UNITED STATES PATENT AND TRADEMARK OFFICE

APPLICATION NO.	FILING DATE	FIRST NAMED INVENTOR	ATTORNEY DOCKET NO.	CONFIRMATION NO.
10/628,032	07/24/2003	William Lin	SII012	3355

Office Action Summary

DETAILED ACTION

Fig. 3

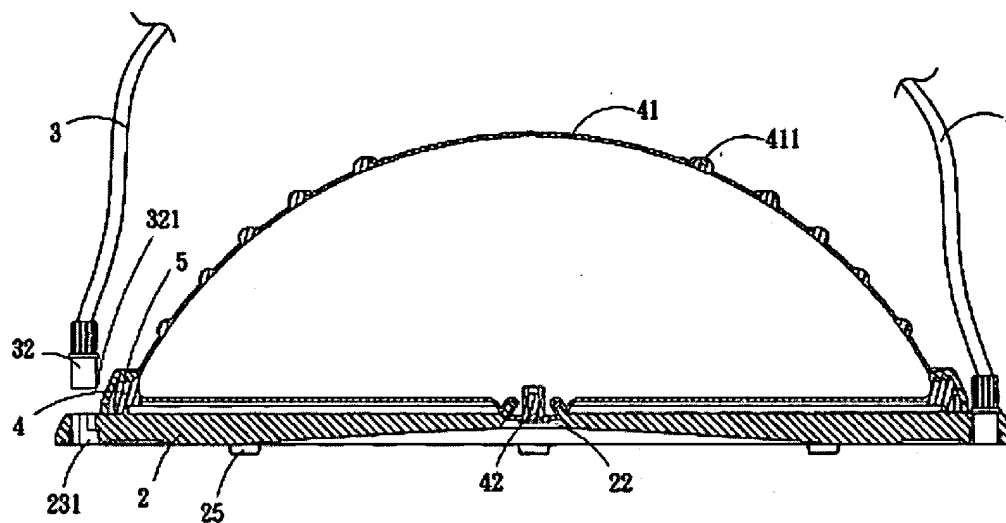
2. As to claims 1-3, 5, 7-9, 14 and 16, Yang discloses a device for aerobic exercise comprising a base frame (2) having a curved planar top surface, elastic pull cords (3), a resilient bladder (4) having a slightly convex top wall portion (41), a bottom wall (A), first and second rim middle portions (B) having projections (123), a surrounding flange (C) extending downwardly from the rim and disposed to surround the base frame and fasteners (6) to secure the flange to the base frame wherein the height of the bladder is shorter than the width of the bladder (see Fig. 3 below). Yang does not disclose that the bladder includes spiral reinforcing ribs or that the top wall portion has a greater rigidity than the middle portion and less rigidity than the bottom wall portion. Lin discloses a bladder having reinforcing spiral ribs and another bladder having projections that are concentrated near the top wall portion of the bladder (see Figs. 2 & 9 respectively). At the time of the invention, it would have been obvious to a person of ordinary skill in the art to add spiral ribs to Yang's resilient bladder to provide enhanced traction for a user to stand thereon and to place massage projections in any of an

array of configurations including having them concentrated near the top wall to provide greater massage effects to the user. The concentration of the massage protuberances at the top wall portion would inherently make the top wall portion more rigid than the middle portion but less than the bottom portion (D) which is visually thicker to provide a strong support for the flange which surrounds the base.
